Access Compliance Report

Public Rights-of-Way

Intersection ID: 2598	Main Street: DRISCOLL_CT	Cross Street: LAGRANDE_DR	Location:	W
ADA ID: BC029F9987A5	Ramp Type: Perp	Initial Pass/Fail: Fail	Overall Compliance: No	Severity Score: 25
Codes/Mitigation Info/Possible Solution		Field Measurements/Component Compliance

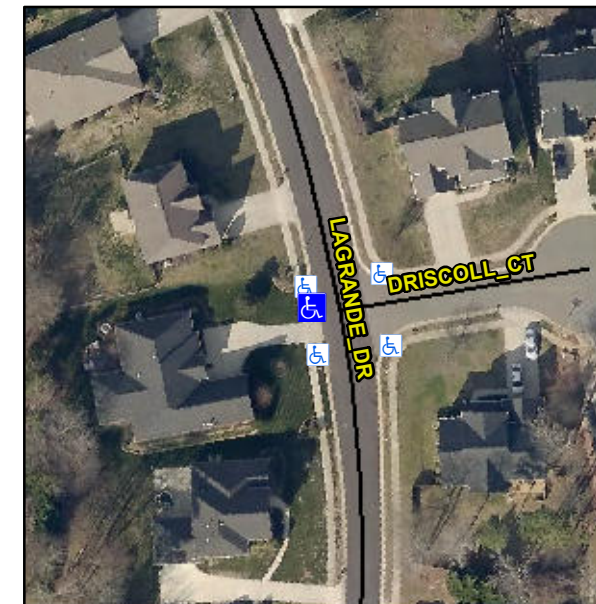
Not Found, R304.2.2, R304.5.3

Compliance	Description	Data	Compliance	Description	Data
N/A	Ramp Length (in)	46.0	No	Ramp Slope (%)	11.8
Yes	Ramp Width (in)	48.0	No	Ramp XSlope (%)	5.3
N/A	Flare Type LT	N/A	N/A	Flare Type RT	N/A
N/A	Flare Slope LT (%)	N/A	N/A	Flare Slope RT (%)	N/A
N/A	Flare Traversable LT?	N/A	N/A	Flare Traversable RT?	N/A
N/A	Landing Length (in)	N/A	N/A	DWS Provided?	N/A
N/A	Landing Width (in)	N/A	N/A	DWS Contrast?	N/A
N/A	Landing Slope (%)	N/A	N/A	DWS Length (in)	N/A
N/A	Landing X Slope (%)	N/A	N/A	DWS Full Width?	N/A
N/A	Landing Curb? (Y/N)	N/A	N/A	DWS Offset (in)	N/A
N/A	Shared Landing?	N/A			
N/A	Gutter Ponding?	N/A	N/A	Gutter Slope (%)	N/A
N/A	Gutter Lip Ht (in)	N/A	N/A	Gutter X Slope (%)	N/A
N/A	Painted X Walk1?	No	N/A	Painted X Walk2?	N/A
	X Walk 1 Direction	To E		X Walk 2 Direction	N/A
N/A	X Walk 1 Width (in)	N/A	N/A	X Walk 2 Width (in)	N/A
	X Walk 1 Slope (%)	3.5		X Walk 2 Slope (%)	N/A
	X Walk 1 X Slope (%)	3.3		X Walk 2 X Slope (%)	N/A

Remove & Replace Entire Ramp.
